**Traffic Engineering Evidence  
Statement**

Proposed Rezoning

**Amendment C88 to Hobsons Bay  
Planning Scheme**

**Prepared for:**  
Precinct 15 Landowners Consortium  
Our reference 14703rep01D03

Figure 4.2 – Street Network Plan

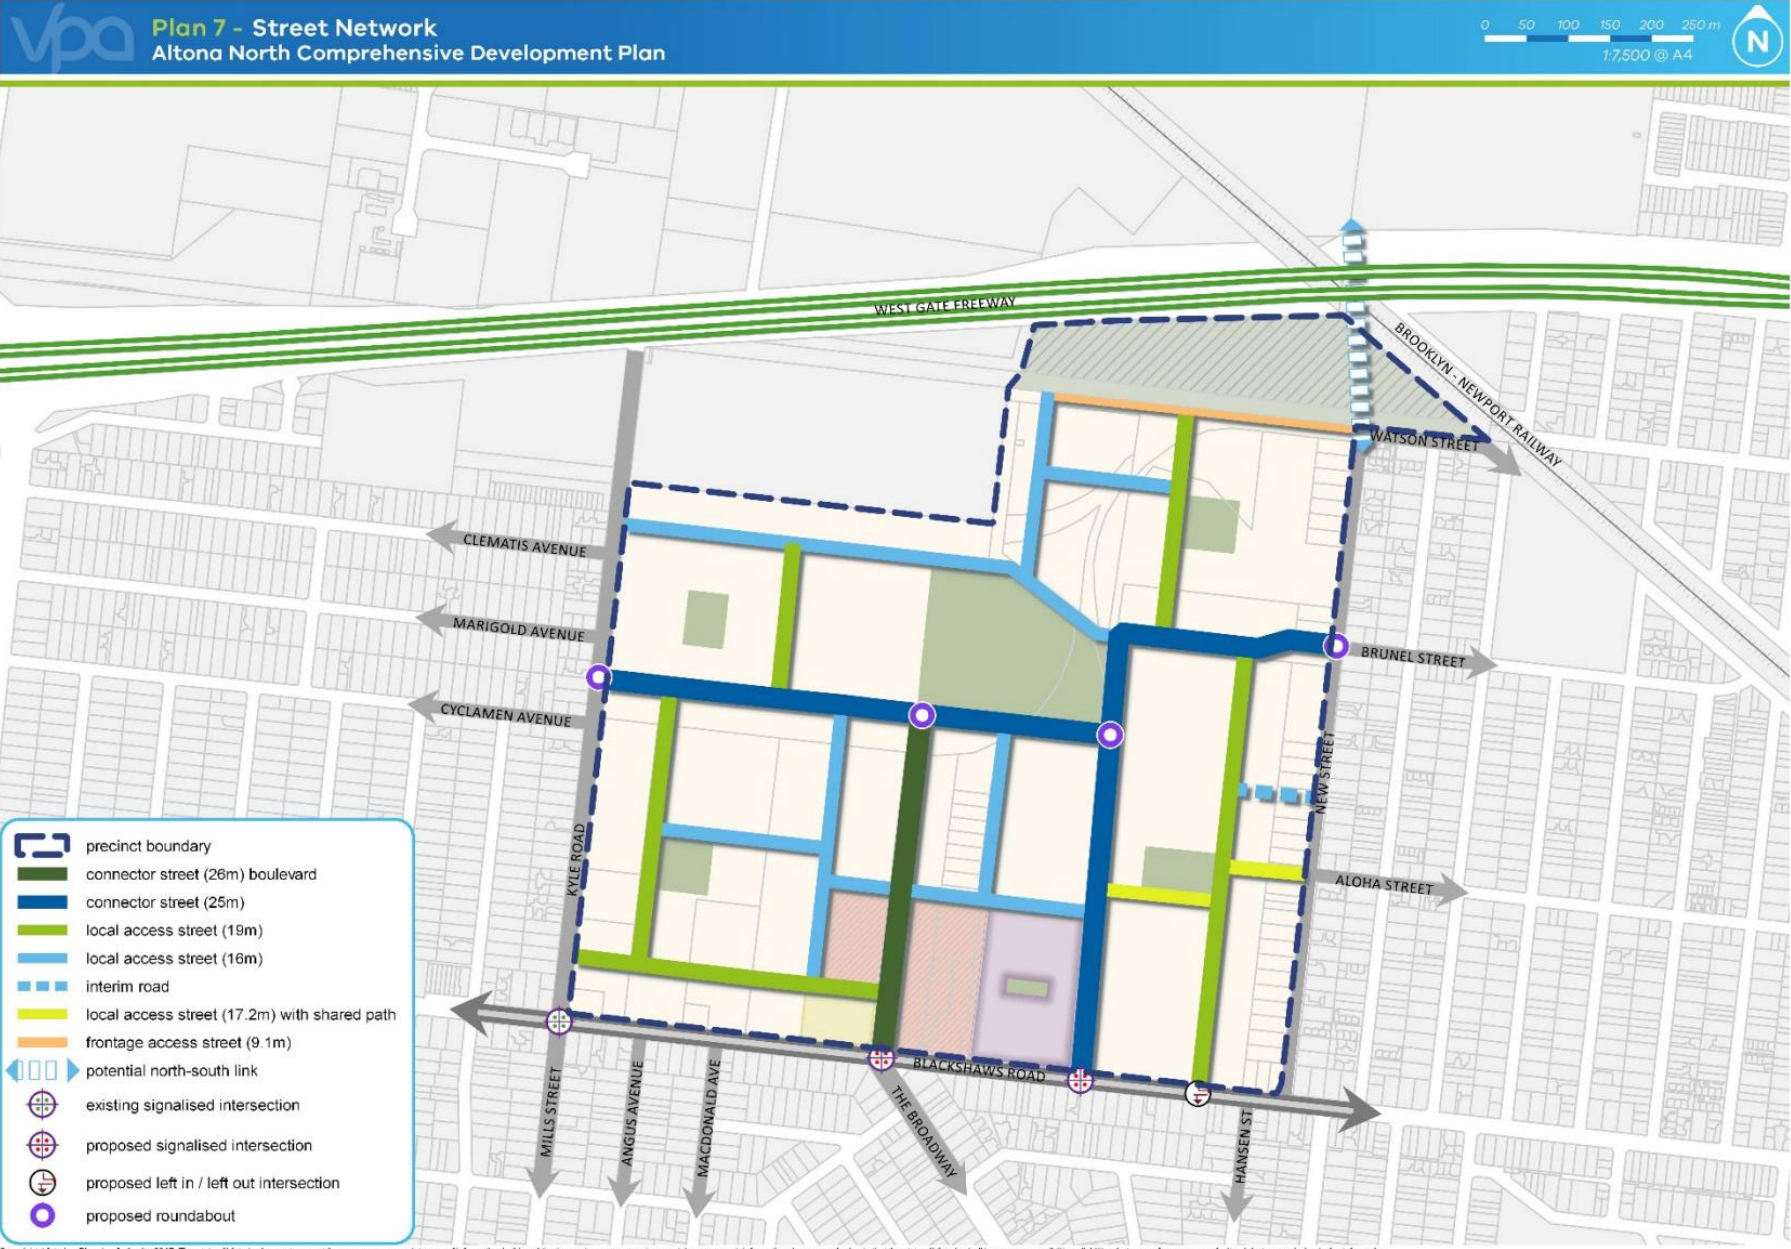
- 4.3.3 Based on the surrounding road network, the street network should be designed with primary access via Blackshaws Road, this being the highest order road available in the vicinity of the site, and the road most capable of catering for an increase in traffic. The proposed street network appropriately seeks to encourage access via Blackshaws Road, with both the Town Centre and Business Park being located closest to Blackshaws Road.

- 4.3.4 Furthermore a boulevard connector and a connector street are proposed to operate north-south through the site with signalised access to Blackshaws Road. These connect to the proposed single east-west connector street running through the precinct between Kyle Road and New Street. This layout will predominantly direct traffic accessing the site to and from Blackshaws Road and is supported.

- 4.3.9 The proposed east-west streets through the precinct align with existing roads at the eastern edge of the precinct at New Street (from north to south at Watson Street, Brunel Street and Aloha Street). The provision of a roundabout at the intersection of the proposed connector street with New Street and Brunel Street will facilitate the local traffic movements as well as the movement of future bus movements through the site and is supported for these reasons.

- 4.3.10 An interim local street connection to New Street is shown between Brunel Street and Aloha Street. In my opinion, the interim location is appropriate in traffic distribution terms and could be retained a permanent link, removing the need for the local street connection to the south at Aloha Street as proposed.

- 4.3.11 The roads do not align at the western edge of the site at Kyle Road, with all three connections to Kyle Road forming staggered intersections with the existing streets in the adjoining existing residential area to the west (from north to south: Clematis Avenue, Marigold Avenue and Cyclamen Avenue).

- 4.3.12 The Background Report notes the offsetting of these intersections as having addressed concerns of potential rat-running within the precinct. In my view, the staggering of the intersections will have only a marginal effect on any rat-running that may occur. It would be preferable for transport connectivity reasons to align the east-west roads with the neighbouring roads to the west, particularly the proposed connector and Marigold Avenue. This would facilitate local traffic movements east-west as well as the movement of future bus movements through the precinct. If there are reasons they cannot be aligned easily, I am comfortable that the alignment as currently shown will function to an acceptable level.

**Figure 8: Potential alternative route via Marigold Street instead of Blackshaws Road**

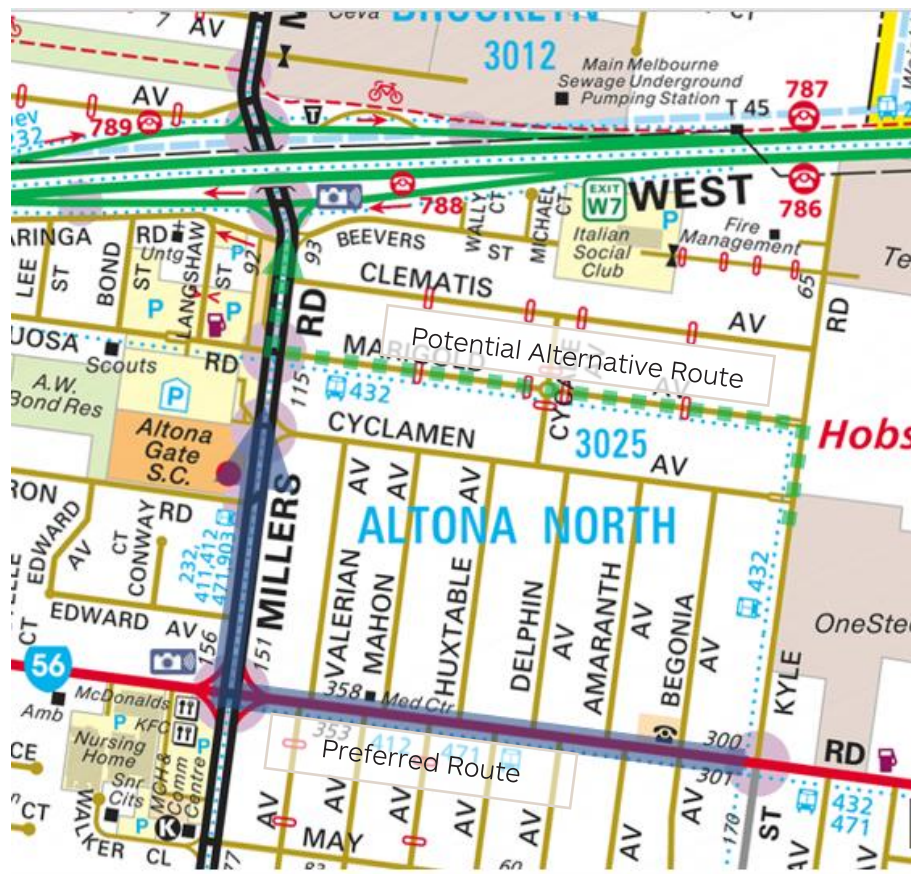
- 4.7.2 Marigold Avenue provides direct access to Millers Road through a signalised intersection catering for all movements.
- 4.7.3 During the morning peak there is limited capacity for traffic to turn right out of Marigold Avenue, as reflected by the long delays modelled by GTA (up to 7 minutes). Traffic turning right out of Blackshaws Road are estimated by GTA to experience much lesser delays of 3 minutes. On this basis, Blackshaws Road is likely to be used in preference to Marigold Avenue during the morning peak.

- 4.7.4 Outside of the morning peak period, the constraint to right turn movements is reduced. During the afternoon peak, traffic returning to the site from Millers Road will turn left into Marigold Avenue. Therefore, Marigold Avenue will be used by some traffic generated by the site. GTA have modelled Marigold Avenue to carry in the order of 4,300 vehicles per day in future, which is an increase in the order of 2,400 vehicles per day from what it currently carries. I agree this is a reasonable estimate of the likely increase in traffic along this route.

- 4.7.5 At present, Marigold Avenue has an approximate 7.0m carriageway width with unrestricted parking permitted along its length on both sides of the

road. Given the estimated increase in traffic, some consideration should be given to introducing traffic management that seeks to balance parking with a need for two-way passing opportunities.

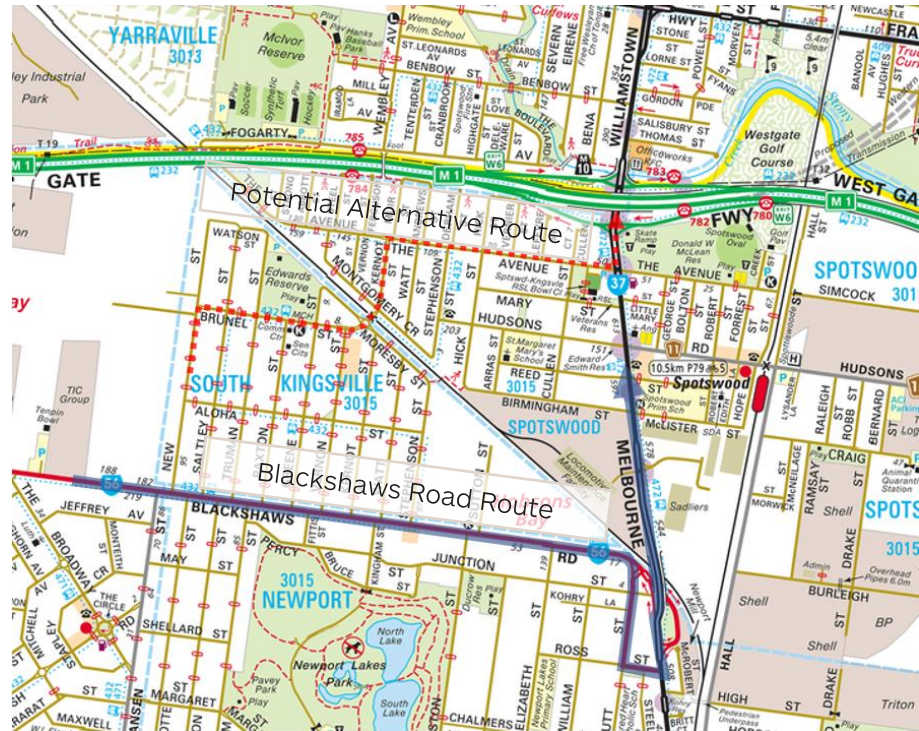
- 4.7.6 Traffic seeking to gain access to Melbourne Road from the precinct has two options as presented in the figure below.
- 4.7.7 Blackshaws Road provides a route via Schutt Street and Ross Street. Brunel Street provides an alternative route via Kernot Street and The Avenue which provides a left turn slip lane access onto Melbourne Road.

- 4.7.8 The modelling results in the 2016 ITS suggest very minimal increases in traffic along the alternative route, with the left turn out movement from The Avenue to Melbourne Road shown to remain at current levels in the morning peak. This was reported in the 2016 ITS to be due to the left turn out movement from The Avenue having no more capacity to support additional movements. In addition, the 2016 ITS suggests that Melbourne Road will become less attractive in the future once the Western Distributor is built. Despite Melbourne Road not having access to the future West Gate Tunnel, many traffic movements are still likely to seek access to the West Gate Freeway from Melbourne Road to access areas to the east of the Yarra River, including the south-eastern suburbs.

- 4.7.9 I would therefore expect some traffic from the precinct to seek access to Melbourne Road to gain access to the West Gate Freeway. Some of this traffic may seek to use Brunel Street to access Melbourne Road via The Avenue given that it provides a more direct compared to Blackshaws / Ross Street route.
